ADDENDUM #1

October 20, 2022

A NEW SHOWROOM AND MAINTENANCE FACILITY FOR SUNSOUTH PROPERTIES COLUMBUS, LLC COLUMBUS, GA

LOADING RAMP DETAIL
SCALE: 1"=1'-0"

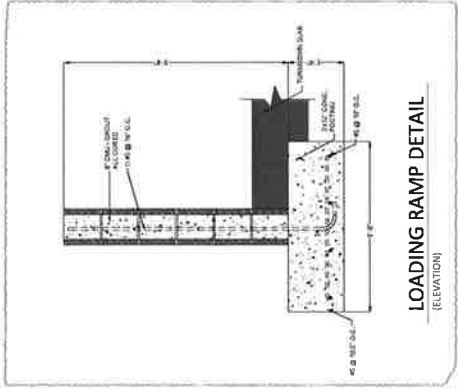
8. Drawing CX.2: Loading ramp details states to refer to structural drawing. There are no details for the loading ramp in the structural drawings. Can these details be provided. See drawings S2.13

SHEET S22
OF 57

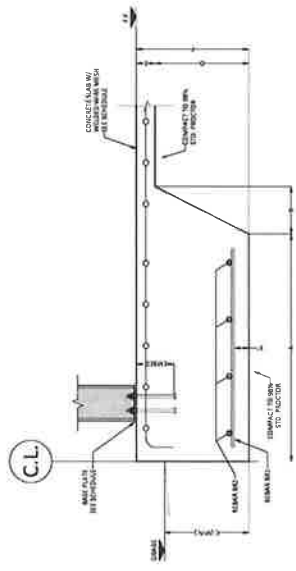
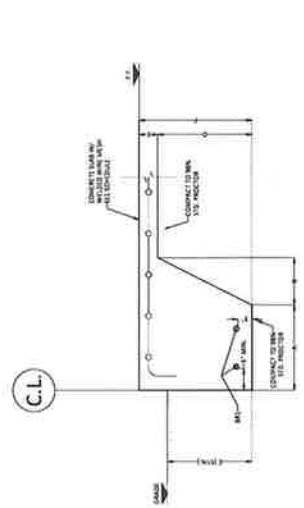
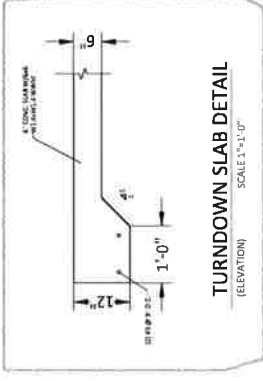
6. Drawing S1.12: Will there be any required decking above the offices? $\frac{1}{2}$ " Plywood
7. Drawing S2.2: Footing F-2 is not shown on the schedule. Can this information be provided. See drawing S2.2.

SHEET NUMBER
A1.2

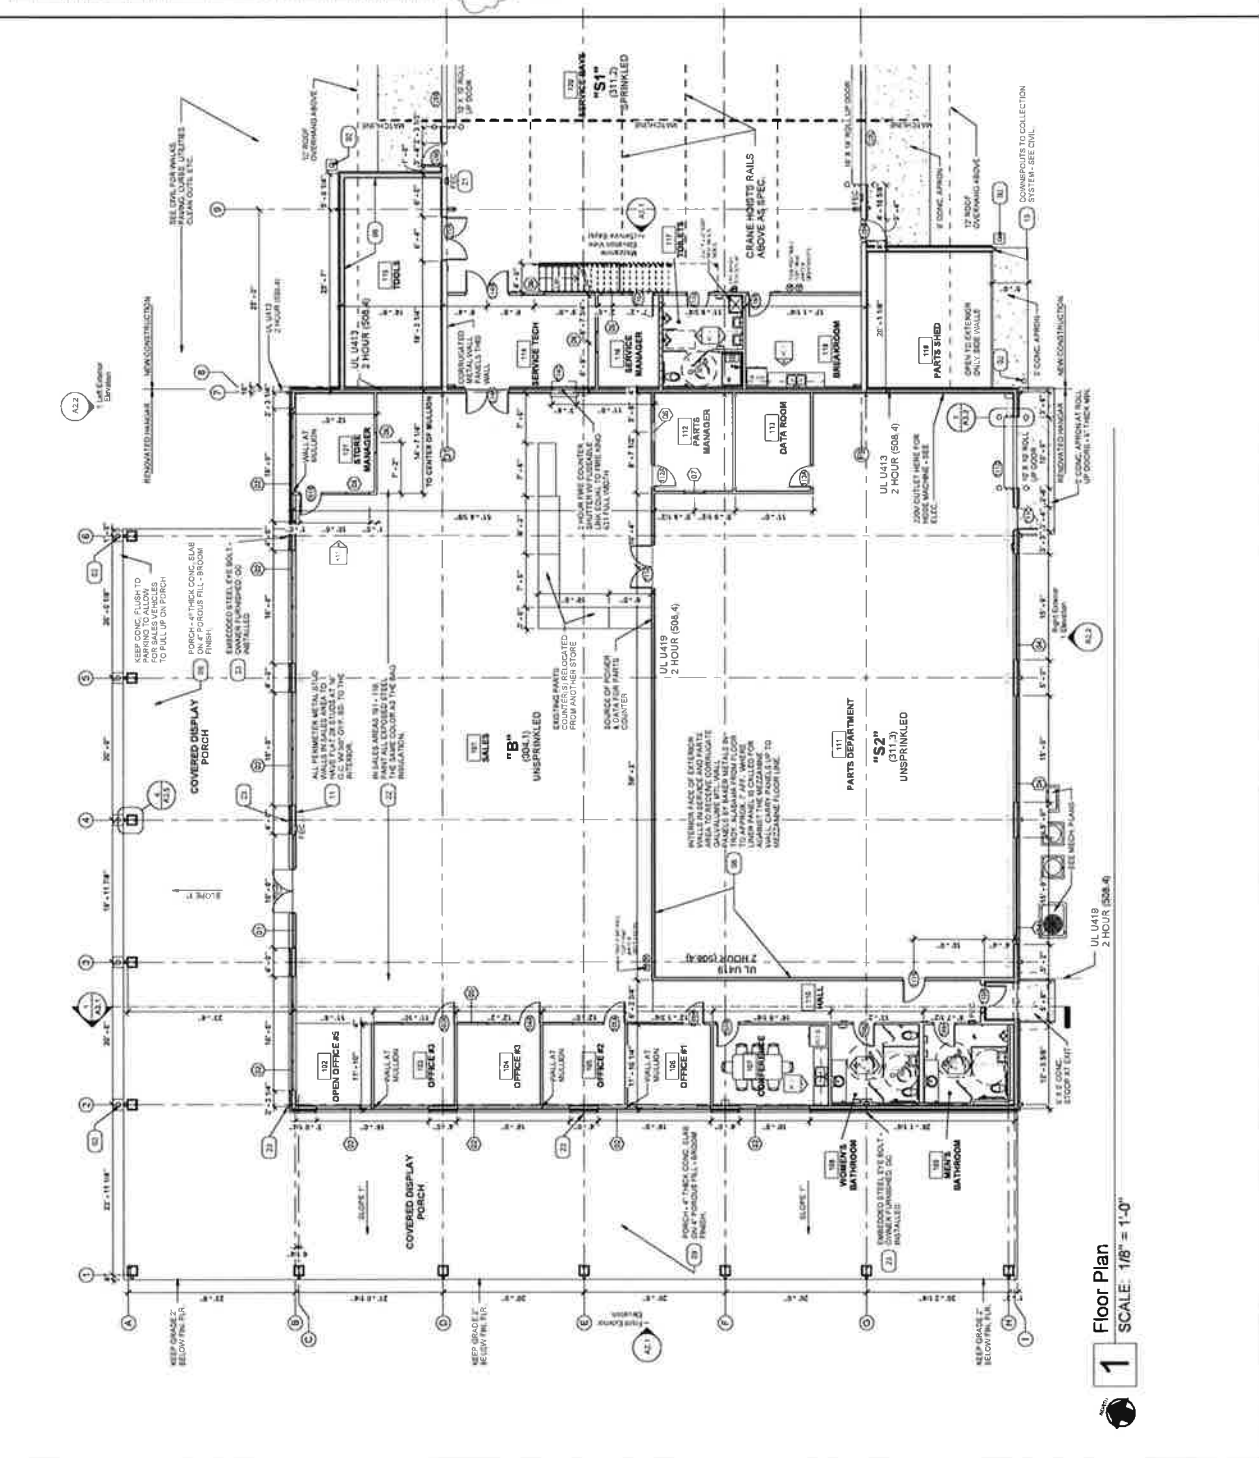
10. Drawing A1.2 (Waste Oil Containers) Wall. Will a footing be required for the 8" CMU Wall? If so, can details be provided? See sheet S1.1 and S1.2.
11. Will engineering be needed for the stud framing? No, just normal wood framing following the NDS for wood construction manual 2018 edition.

SHEET NUMBER	A1.6
DATE	
PROJECT

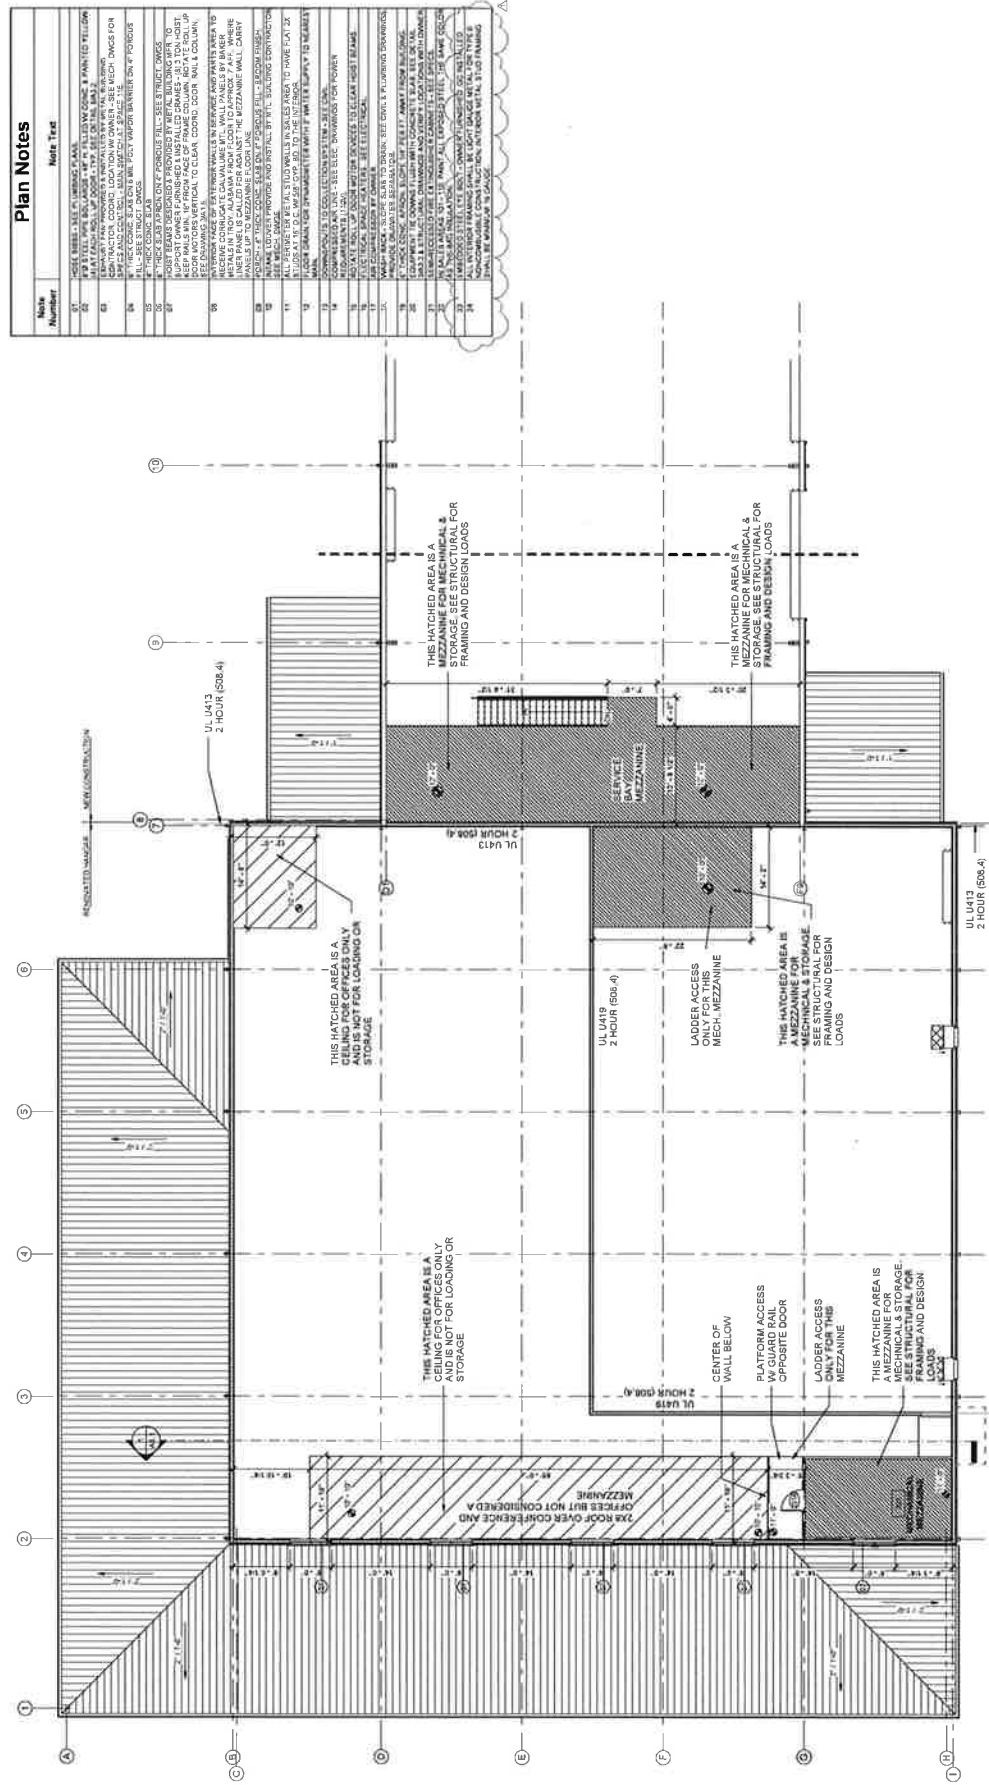
5. Refer to Sheet A1.6 and delete reference to diaper changing table.
6. Refer to Details 1/A3.1 and 1/A3.5 and delete reference to 5/8" cdx over steel purlins.
